文件编号 Document No.	ESP-00-2-007-03	文件名称 Document Name	产品/工艺变更通知 Product/Process Change Notice (PCN)
文件版本 Document Version	1.1	保存期限 Retention Period	3 年 3 years

ESP8285 系列芯片增加封测代工厂
Add a new Assembly and Test Manufacturing (ATM) plant for ESP8285 Series of Chips

PCN 编号 PCN No.	PCN-03-20190917	提出日期 Issue Date of PCN	2019/9/17
产品名称 Product Name	ESP8285 Series of Chips (See below for details)	变更日期 Proposed Date of Change	2019/10/8
封装类型/尺寸 Package Type/Size	QFN 5X5	首次出货日期 Proposed Date of First Shipment	2020/1/1

产品外形图 Product Outline Diagram Comparison

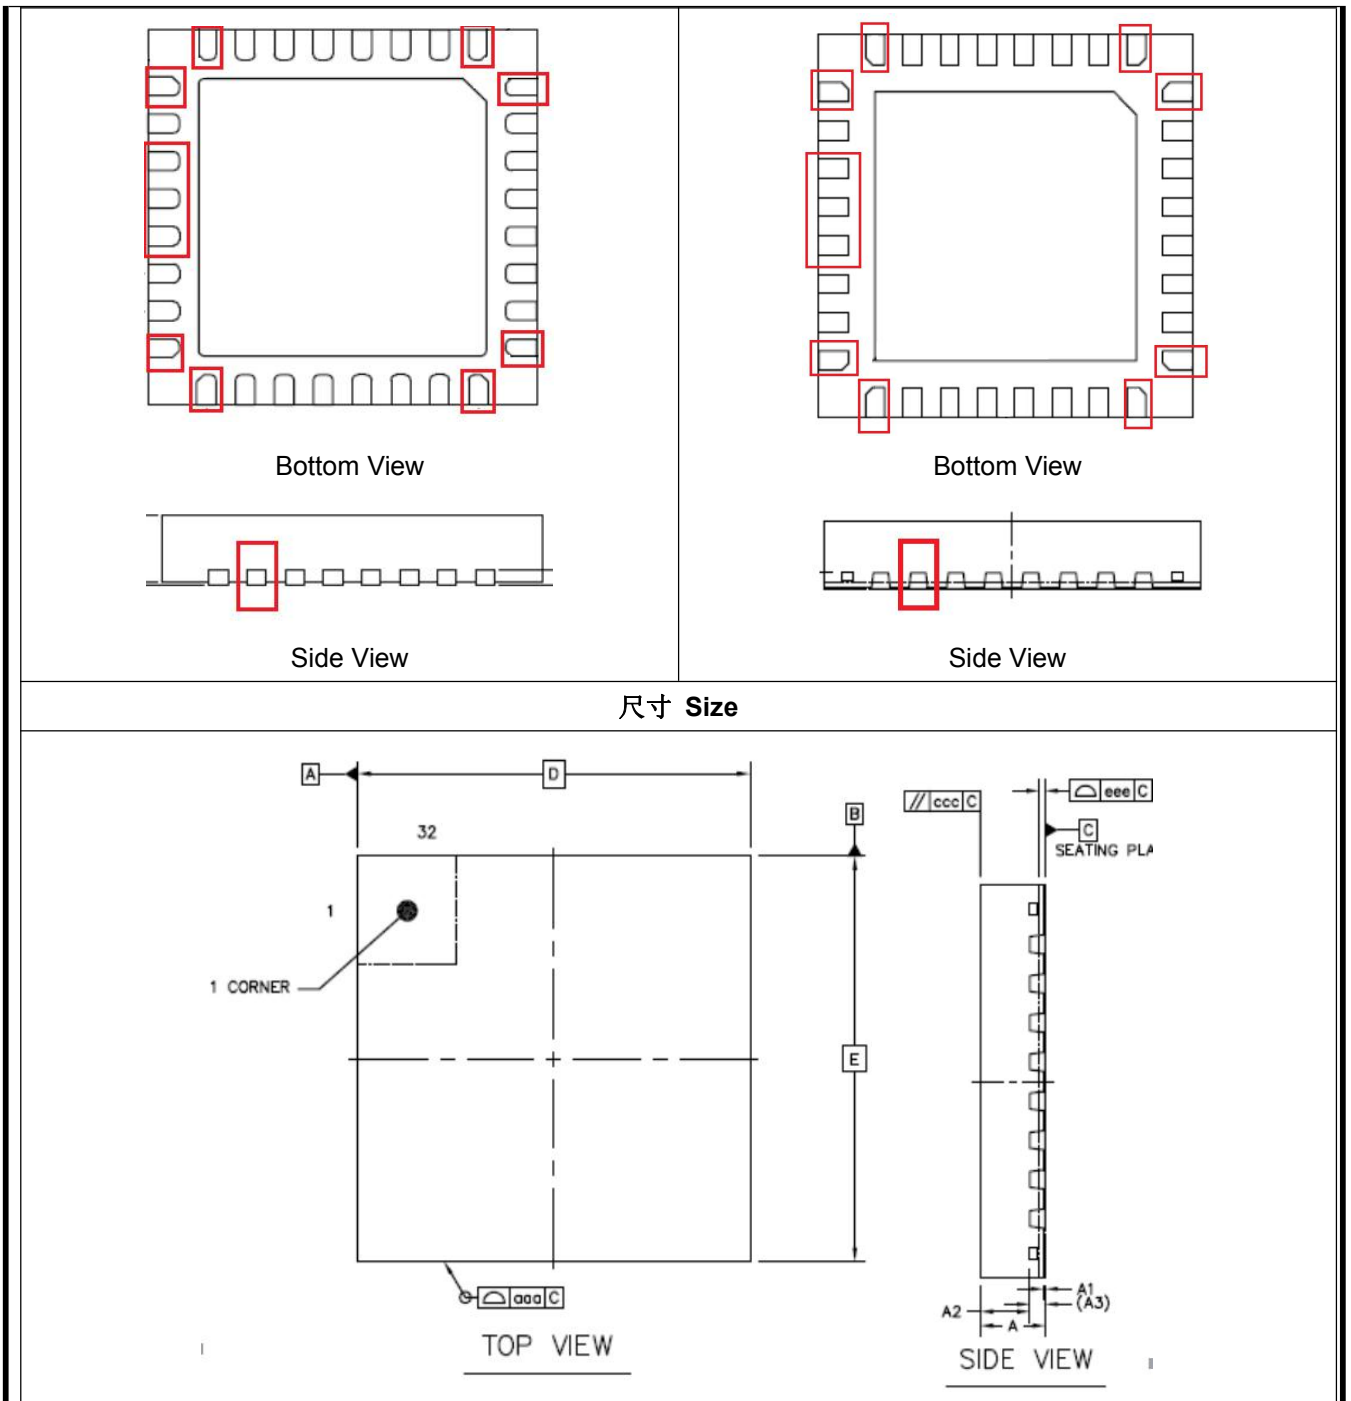
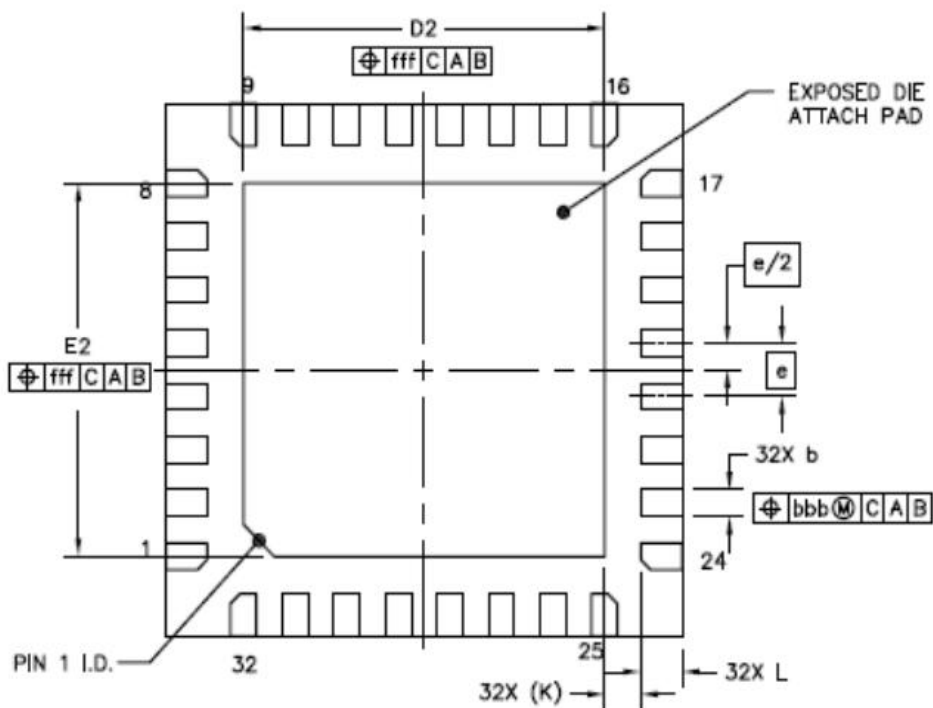
变更内容/Proposed Change:
 增加江苏长电科技股份有限公司 (JCET) 为 ESP8285 系列芯片的封测厂。
 Espressif added a new Assembly and Test Manufacturing (ATM) plant, Jiangsu Changdian Elec. Tech. (JCET), to its supply chain to produce ESP8285 series of chips.

引脚形状 Pin Shape	
Unisem Unisem Cheng Du Co., Ltd	JCET 江苏长电科技股份有限公司
引脚顶为弧形。 The head of the pads are circular. 四个边角对应的 8 个引脚顶形状与其他引脚不同。 The pads located on both sides of each corner of the chip (a total of eight pads) have a different shape, compared with to all other pads.	引脚顶为直线。 The head of the pads are rectangular. 四个边角对应的 8 个引脚顶形状与其他引脚不同。 The pads located on both sides of each corner of the chip (a total of eight pads) have a different shape, compared with to all other pads.

Unit: mm	Unisem Unisem Cheng Du Co., Ltd			JCET 江苏长电科技股份有限公司		
	MIN	NORM	MAX	MIN	NORM	MAX
尺寸						
A	0.8	0.85	0.9	0.8	0.85	0.9
A1	0	-	0.05	0	-	0.05
A3	0.203REF.			0.203REF.		
D	4.95	5	5.05	4.9	5	5.1
E	4.95	5	5.05	4.9	5	5.1
D2	3.65	3.7	3.75	3.4	3.5	3.6
E2	3.65	3.7	3.75	3.4	3.5	3.6
b	0.2	0.25	0.3	0.2	0.25	0.3
e	0.5BSC			0.5BSC		
L	0.35	0.4	0.45	0.3	0.4	0.5
切角	C0.300×45°			C0.300×45°

- 影响产品外观，不同封装测试厂生产之芯片引脚尺寸和引脚形状不同。
The appearance of the products will not be exactly the same: the size and shape of chip pins will vary from different plants.
- 如客户产线贴片模具可兼容新增封装测试厂生产之芯片，则无影响。
Customers using SMT molds that are compatible with chips produced by the newly added plant will not be
